March 6, 2017

Doug Anderson  
Project Manager  
U.S. Environmental Protection Agency  
windows@energystar.gov

In earlier comments on the proposed new Energy Star<sup>®</sup> program for exterior and interior storm windows and panels, the question was asked how much the frame material of the storm window affects the overall performance. The framework document and referenced papers note that differences in performance between storm window products are dominated by the glazing type (low-e or not) and air leakage reduction, and therefore suggested using emissivity, solar transmittance, and air leakage as the primary metrics for the program. Unlike primary windows, differences in frame material should have minimal impact because even for aluminum framed storm windows (which are the vast majority due to structural, durability, and design benefits), the storm window panel is attached to nonmetal components like wood brick mold, wood blind stops, inside drywall, or wood trim that act as a thermal break. But to address this question, I have included some additional analysis here that you might find useful and confirms this conclusion.

**Figure 1: Energy Performance Indices for Exterior Panels with High Solar Transmittance**

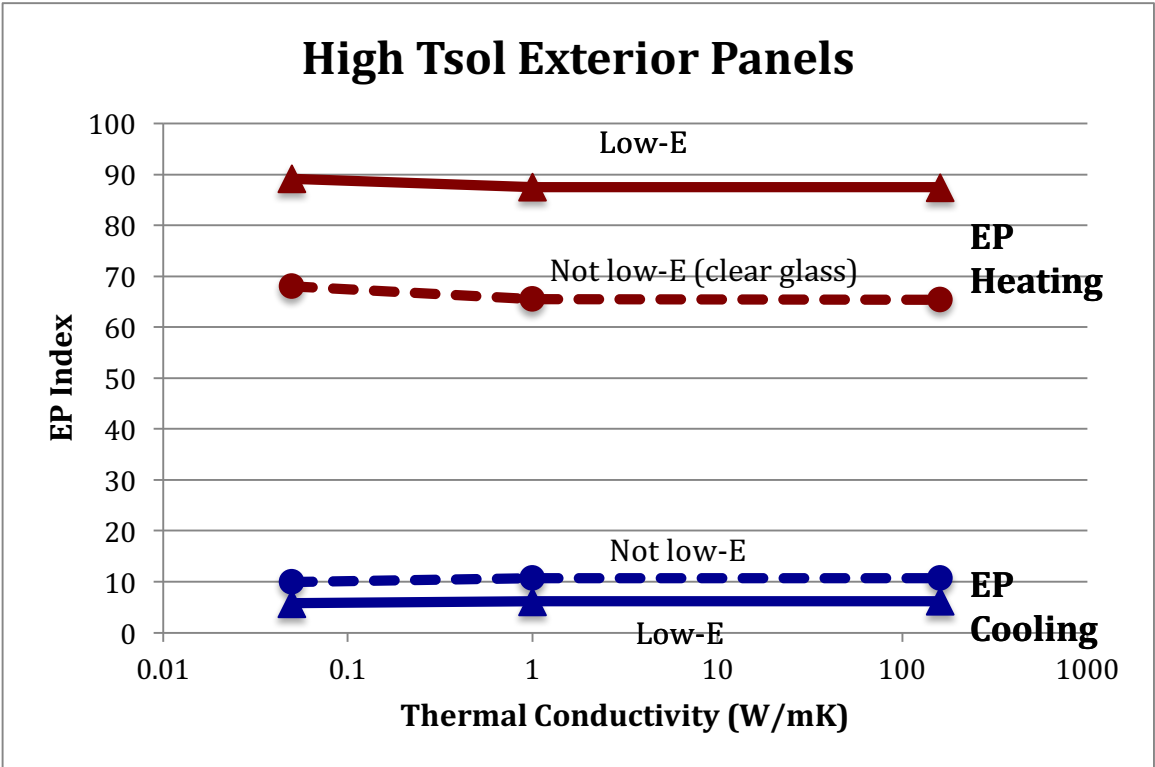
Figures 1-2 show EP<sub>H</sub> and EP<sub>C</sub> results from LBNL’s analysis for different exterior panels as a function of thermal conductivity.

- The primary application for storm windows has been to reduce heating energy use in cold climates, and this is seen in the high  $EP_H$  in Figure 1, with low-e giving a clear and significant benefit. There are still some cooling savings ( $EP_C$  is greater than zero) but this part is clearly secondary to the heating savings.

- The flat lines show that thermal conductivity does not have any significant impact on  $EP_H$  and  $EP_C$ , even when changing the thermal conductivity by a factor of over 3000. This confirms the conclusion from part 1 that frame material and conductivity of the attachment alone is far less important to overall energy performance of the system than glazing properties (emissivity and solar transmittance).

Figure 2: Energy Performance Indices for Exterior Panels with Low Solar Transmittance

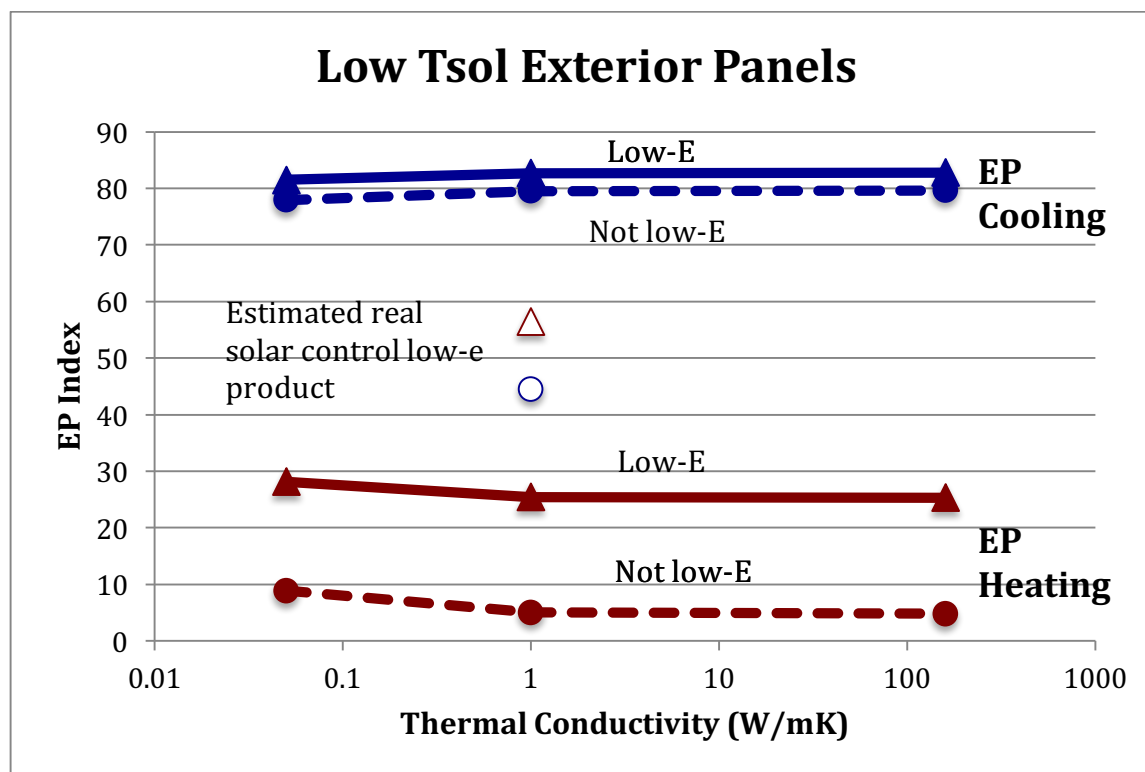
- As expected, low solar transmittance raises the cooling energy performance  $EP_C$  for cooling-dominated climates, but lowers the heating energy performance  $EP_H$  in heating-dominated climates by blocking beneficial solar heat. Low-e glazing improves upon this and provides higher heating EP. Again, this is using a hypothetical very low solar transmittance, and the estimated performance of a real solar control low-e product shows a good balance with relatively high EP for both heating and cooling – good for mixed climates with both significant heating and cooling.
